Inglewood Business Improvement Area Response

Re: Inglewood BIA Comments on Blues By Battistella

February 9, 2024

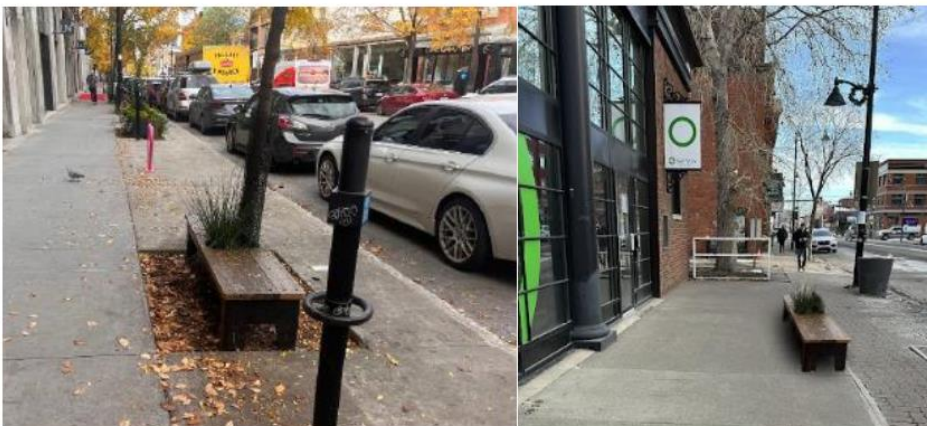
Pedestrian-friendly sidewalks and accessible retail access are essential components for the main street experience. The BIA supports both retail and residential entrances at street level. An elevated setback creates a negative impact on the street interface, it directly impacts retail vibrancy. This can be seen every day at the "Rosso building" on the corner of 13th Street and 9th Avenue in Inglewood. Retail tenants struggle to survive and there is a high turnover of retail tenants because the combination of set back and elevation deters people from a casual entry into the business, and passing vehicles cannot see what is being offered in the business. An elevated setback is not only aesthetically poor, it encourages crime. This same building

is a consistent target of break and enters, much higher than any other building along 9th Avenue.. Again, this is because the set back creates shadow and less visibility, ideal for criminal activity. The BIA advocated to eliminate the elevated setback at the Irvine development, and as a result the retail experience is far more in line with the feel of the street. An adjacent property, The Irvine, recently built, did not include the flood fringe which makes it a much better pedestrian and retail experience than the “Rosso building”.
